PRODUCT/PROCESS CHANGE NOTIFICATION

10%,20%,30,40% Humidity Indicator Card (Cobalt Free)

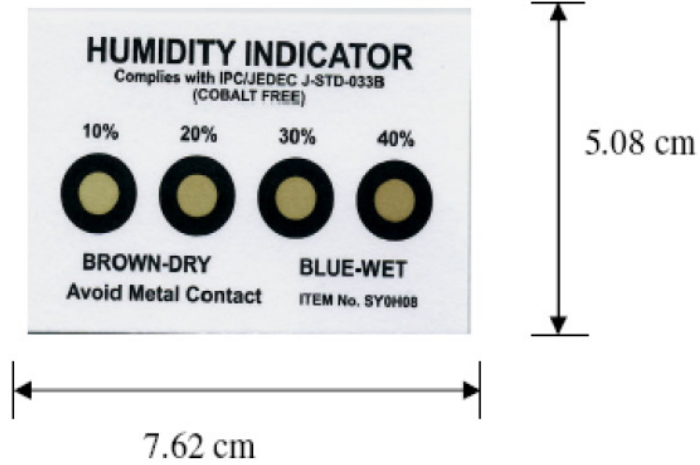
Reason for change(s): <input type="checkbox"/> Products Package Outline Dimension <input type="checkbox"/> Electrical/Optical Specification <input type="checkbox"/> Material <input type="checkbox"/> Equipment <input type="checkbox"/> Data Sheet <input checked="" type="checkbox"/> Packing <input type="checkbox"/> Other	Detailed description: Base on the standard of Reach and IPC/JEDEC J-STD-033B, the HIC(Humidity Indicator Card) can not use Cobalt Dichloride since 2011 April. The HIC have to modify Cobalt free uniformly, so the colour will be changed from brown (DRY) to blue (WET). Please refer to the attachment for appearance.
---	---

DESCRIPTION	CHARACTERISTIC
Product Name	Humidity Indicator Card(Cobalt Free)
Indicates	10%,20%,30%,40% relative humidity
Material	White Blotting Paper 300 g/m ²
Dimensions	5.08cm*7.62cm (±0.3cm)
Color Change	Brown(Dry)→Blue(Wet)
Standards	IPC/JEDEC J-STD-033B
